EARLY DESIGN GUIDANCE #2

AMERICAN CAMPUS COMMUNITIES

4555 ROOSEVELT WAY NE
SEATTLE, WA 98126

DPD NUMBER: 3015513
NORTHEAST DRB MEETING: 02/24/2014

GREEN SCREEN
PARKING SCREENING

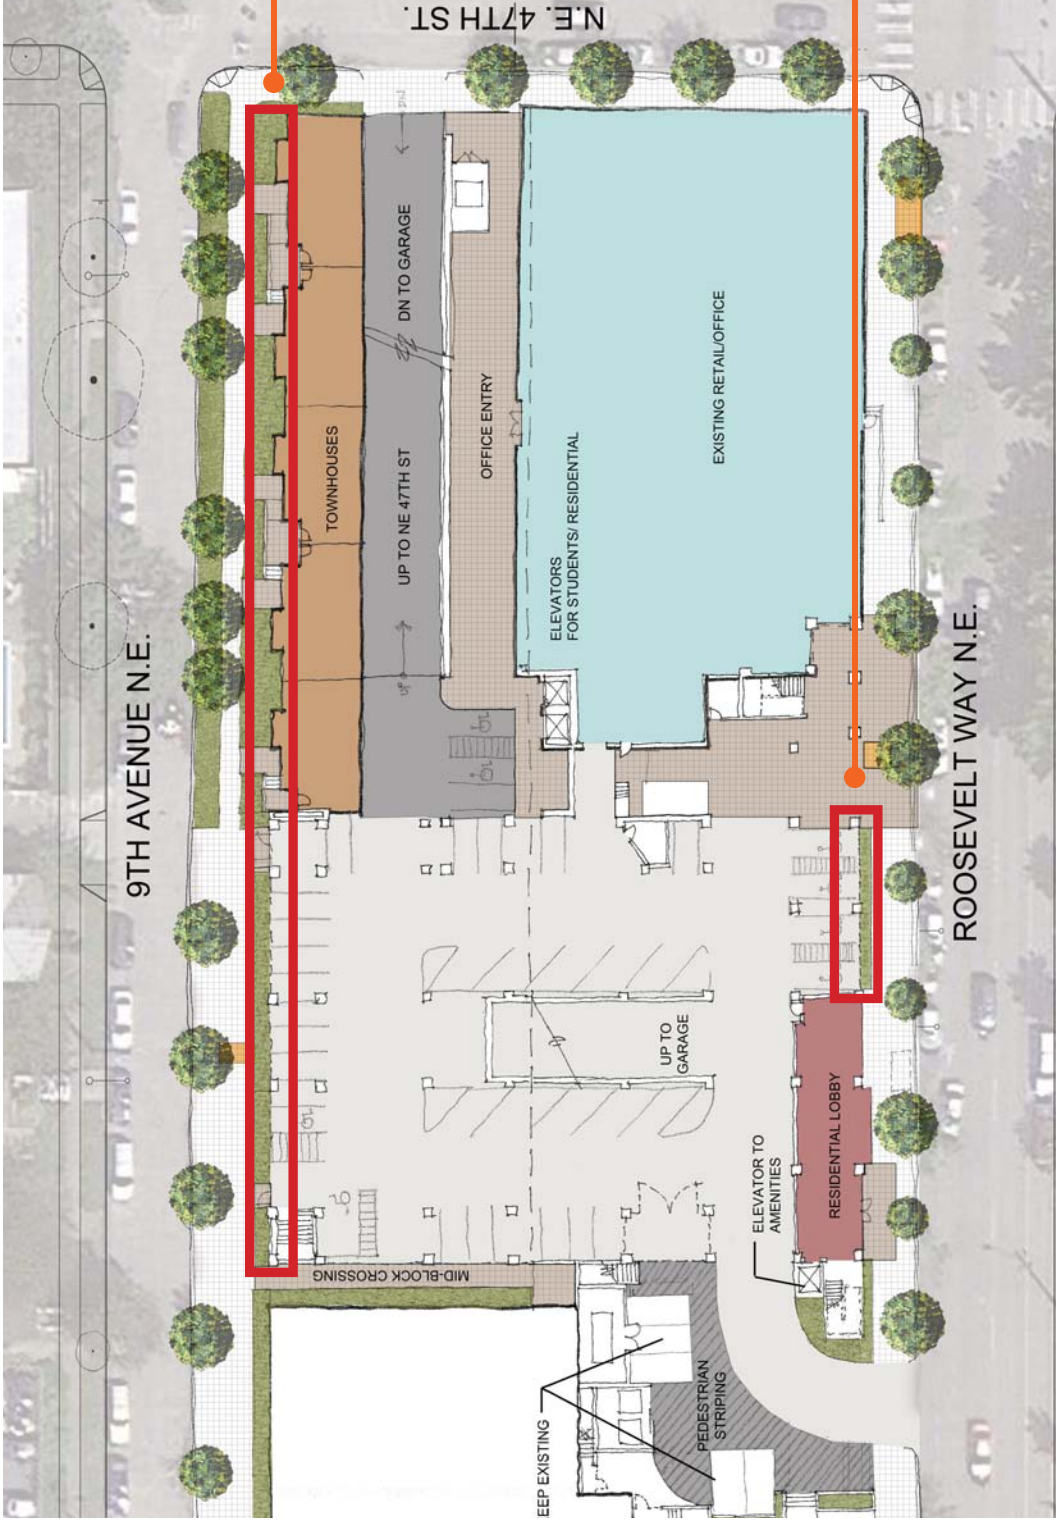
To prevent vehicle lights from affecting adjacent properties, driveways and parking areas for more than two (2) vehicles shall be screened from adjacent properties by a fence or wall between five (5) feet and six (6) feet in height, or solid evergreen hedge or landscaped berm at least five (5) feet in height. If the elevation of the lot line is different from the finished elevation of the driveways or parking surface, the difference in elevation may substitute for a portion of the required height of the screen so long as the screen itself is a minimum of three (3) feet in height. The Director may waive the requirement for the screening if it is not needed due to changes in topography, agreements to maintain an existing fence, or the nature and location of adjacent uses.

Response: We intend on reusing the existing driveway and parking areas and adding green screens and perforated metal panels along the East and West Elevations.

GREEN SCREEN
PARKING SCREENING

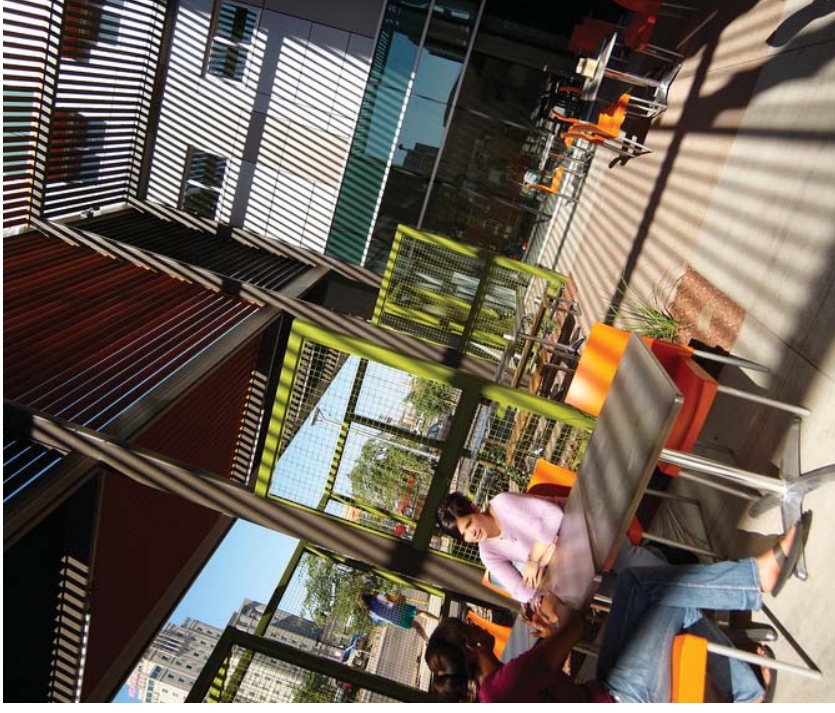
Within a structure, street-level parking shall be separated from street-level, street-facing facades by another permitted use. This requirement does not apply to access to parking meeting the standards of subsection 23.47A.032.A.

23.47A.032.A.b. If access is not provided from an alley and the lot abuts only a principal pedestrian street or streets, access is permitted from the principal pedestrian street, and limited to one two-way curb cut.

Response: We placed townhomes along west elevation on 9th Avenue and placed the residential lobby along the east elevation on Roosevelt. The parking has been mitigated from the streets and will be screened by architectural and green screening.
